Metro Outer Joint Development Assessment Panel Agenda

Meeting Date and Time: Monday, 4 September 2023; 10:00am
Meeting Number: MOJDAP/270
Meeting Venue: Electronic Means

Subject: Response to application seeking Development Approval for a childcare premises at Lot 194 and 193 (No.4 and 6) Malibu Road, Safety Bay.

That the Metro Outer Joint Development Assessment Panel resolve to **REFUSE** Development Application reference DAP/23/02487 and the amended plans and supporting information received on 10 July 2023:

Revised Drawings

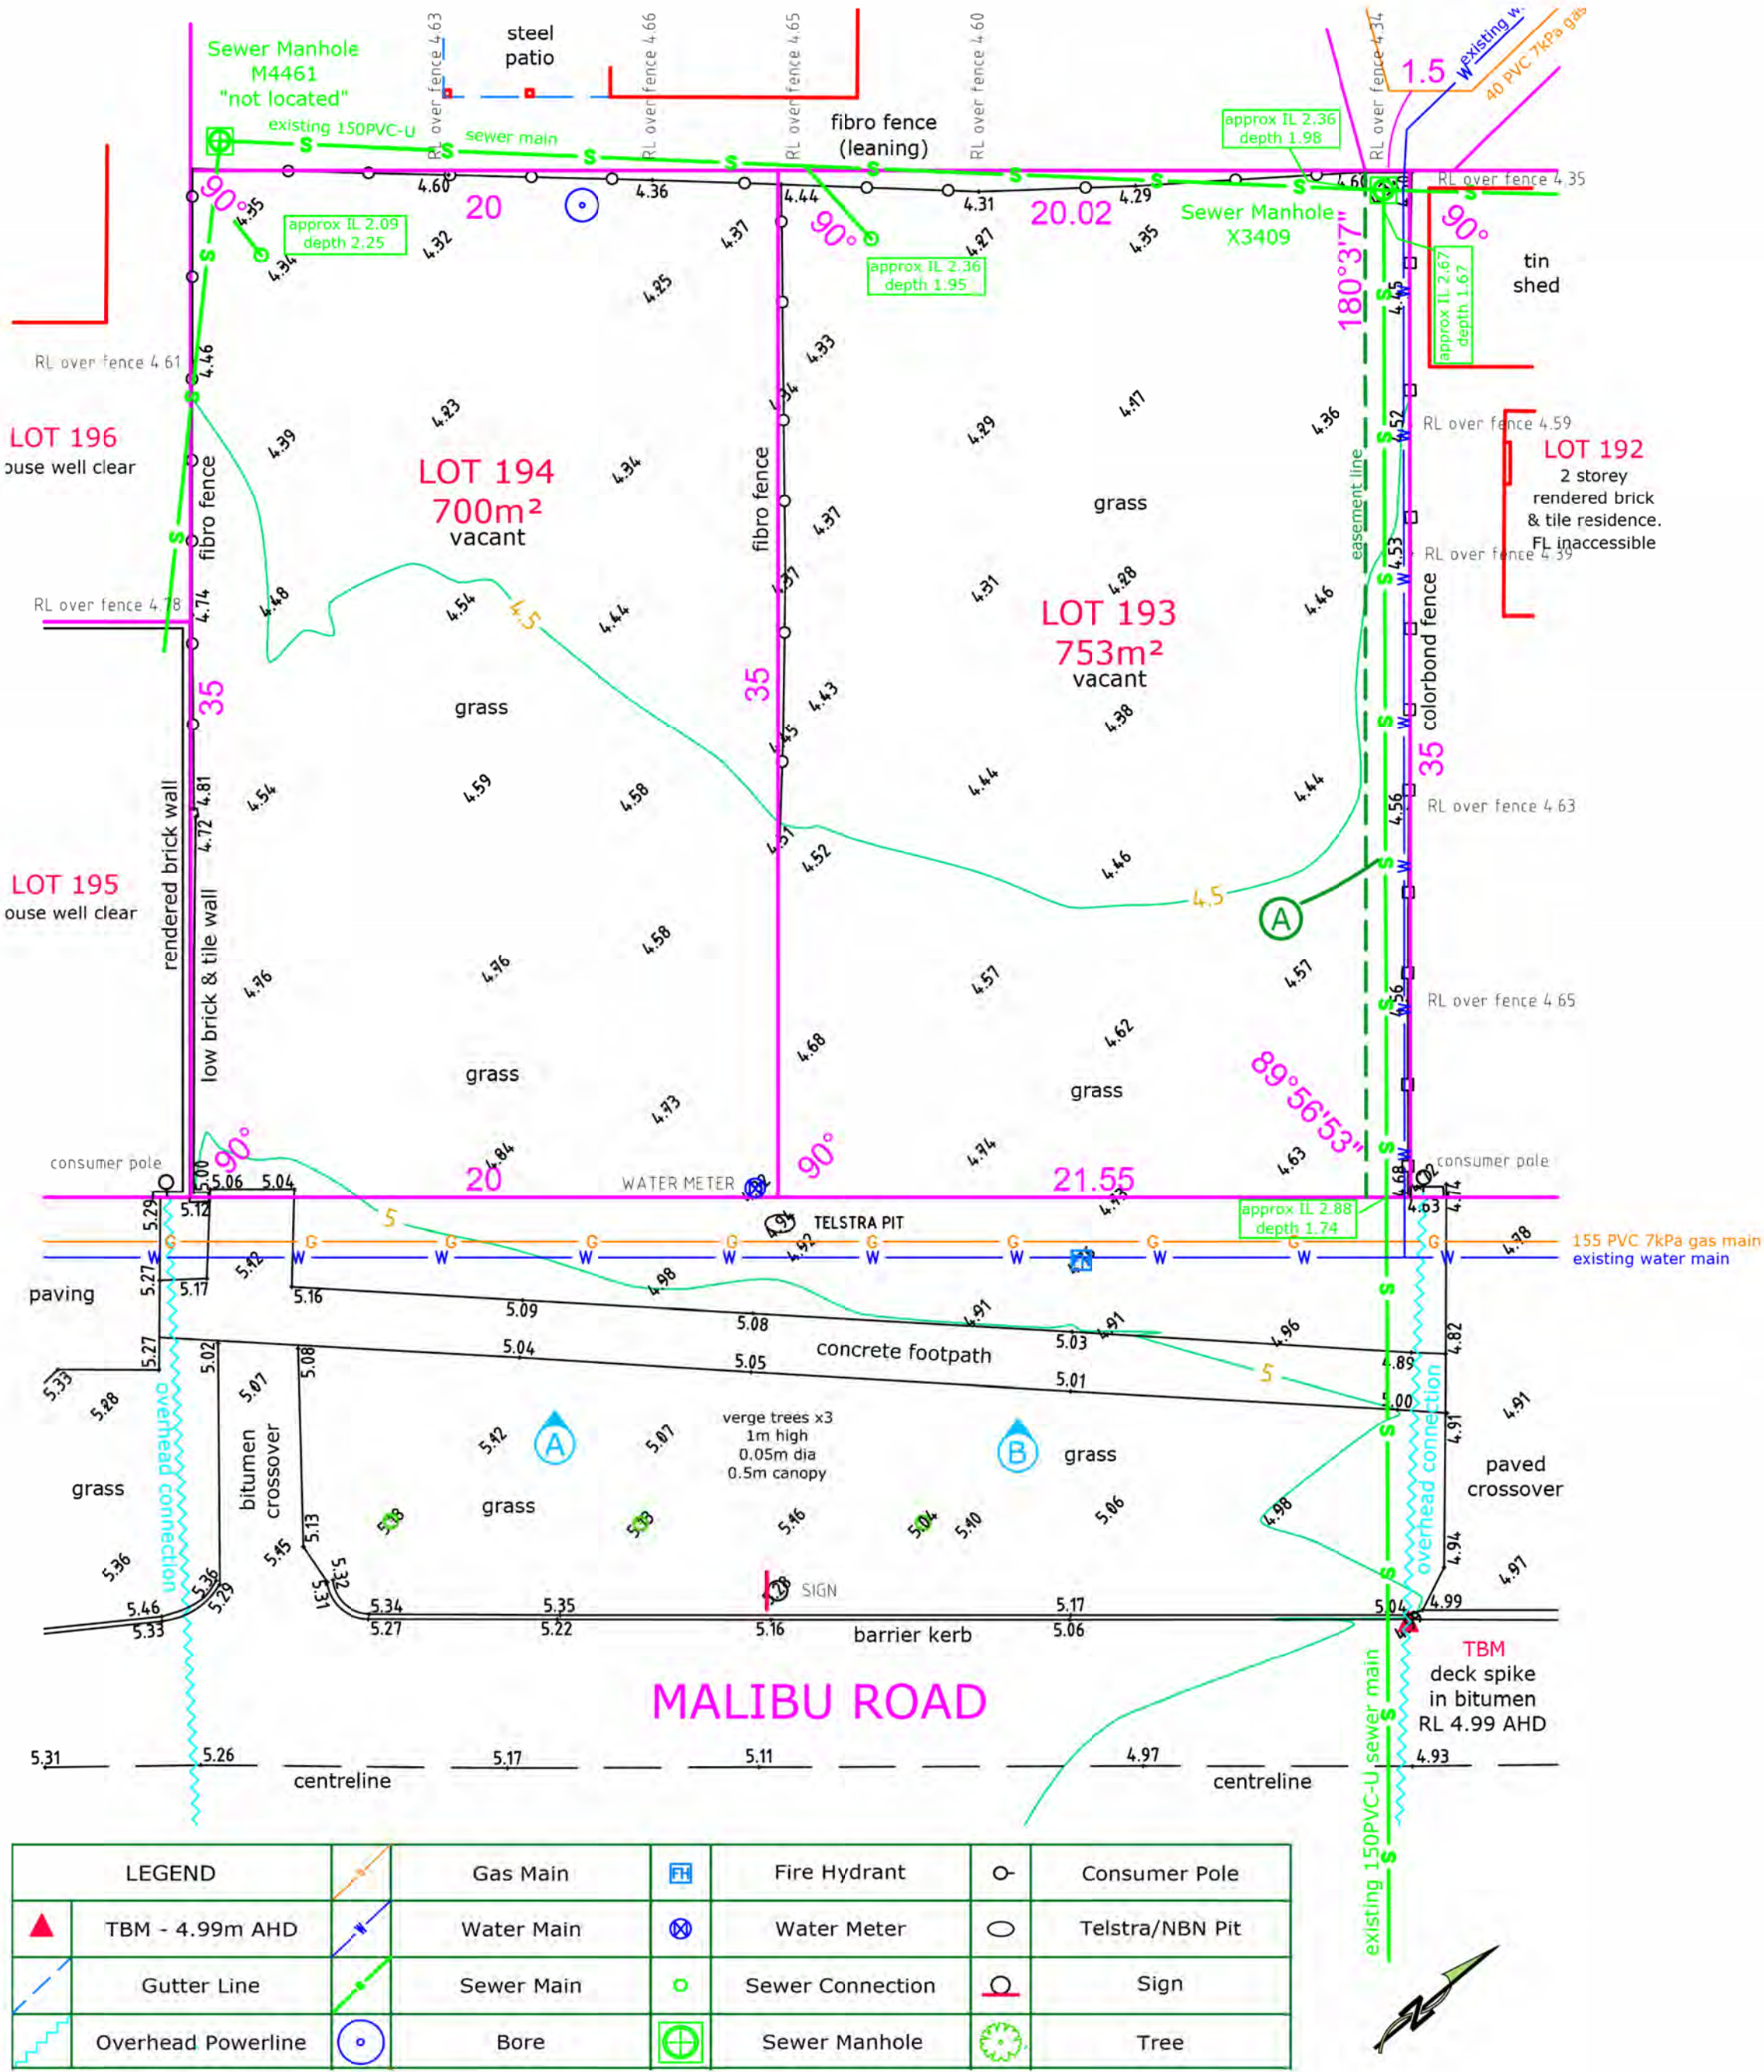
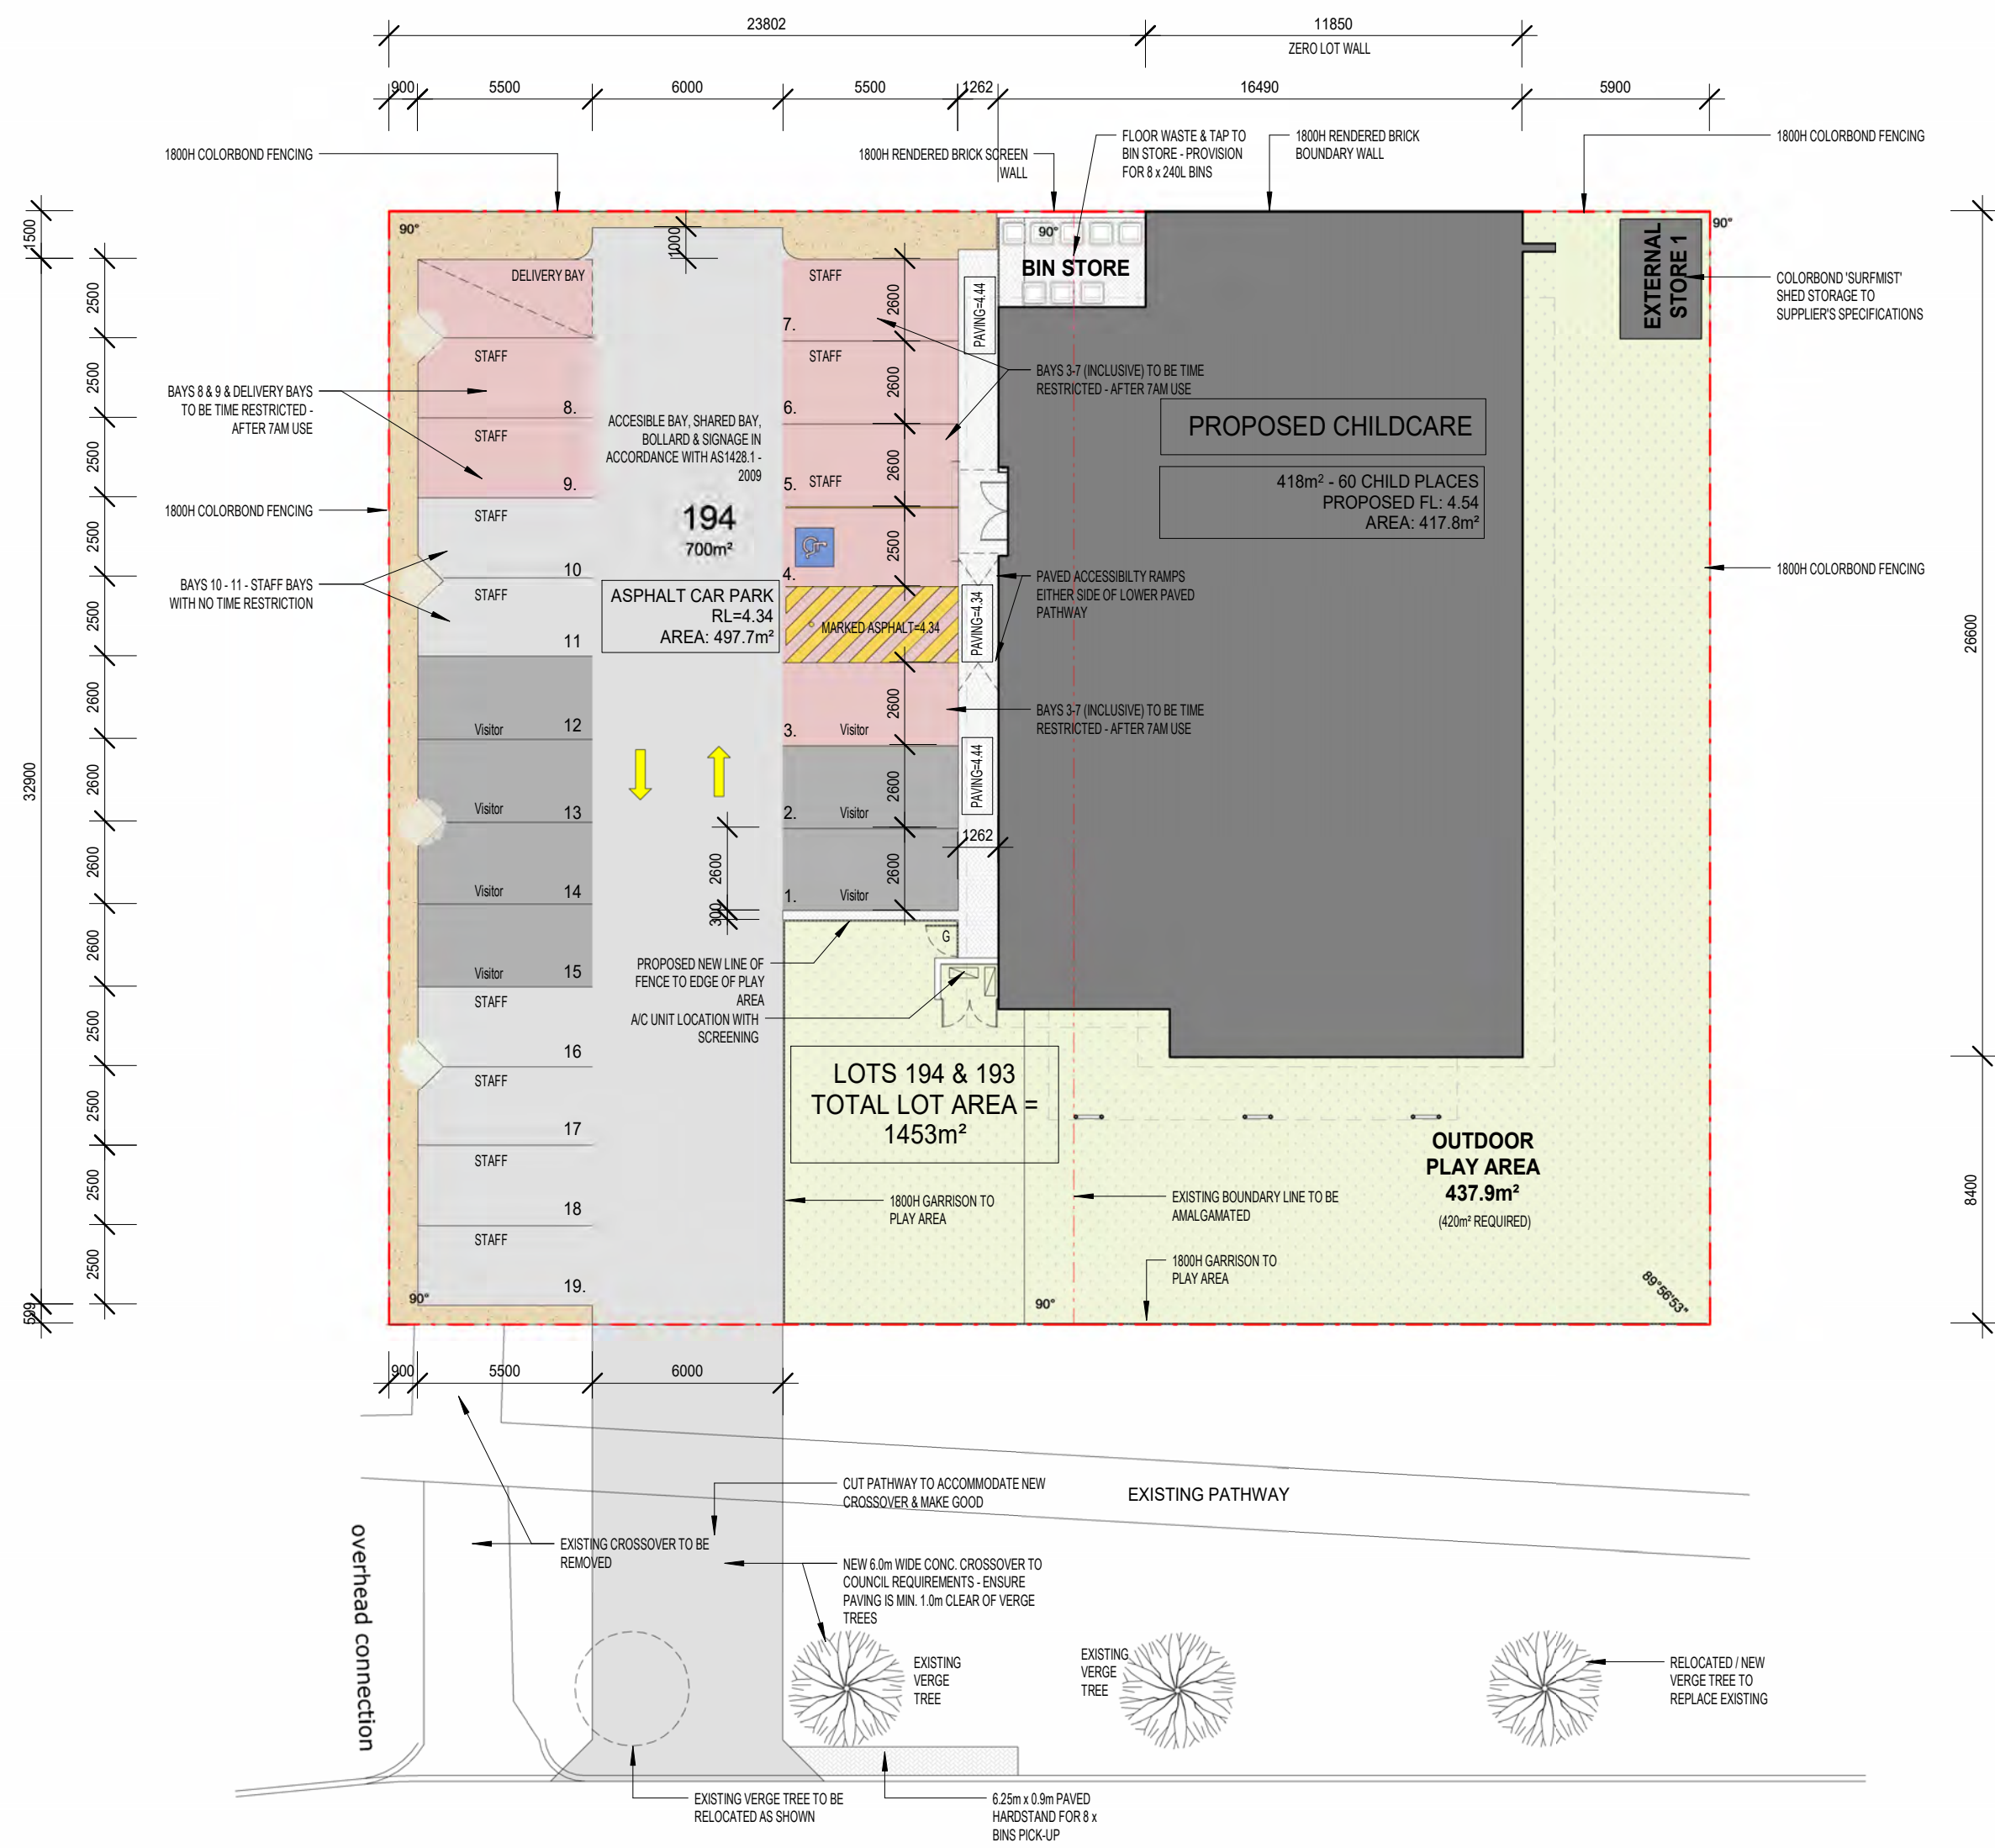
By “flipping” the design, the particulars of the proposed development, such as noise generation, traffic generation, parking requirements, operating hours, number of children and staff, etc. will not change. As a result, the findings of the traffic report are unchanged. In relation to the access location, we acknowledge that the crossover will move closer to the Safety Bay Road and Malibu Road intersection. However, the preliminary advice from the traffic engineer is that this an acceptable outcome. The findings of the EIA will improve.

To address the City's third reason for recommending refusal and to meet the relevant deemed-to-comply requirements outlined in State Planning Policy 7.3 – Residential Design Codes (**the R-Codes**), the following amendments to the Development Plans have been made:

As a result of these amendments to the Development Plans, the proposed development now satisfies the 'Lot boundary setback' deemed-to-comply requirements outlined in SPP 7.3. Therefore, the proposed development now presents an acceptable level of impact to the adjoining residential property situated to the west of the subject site, with respect to the height of the rear boundary wall.
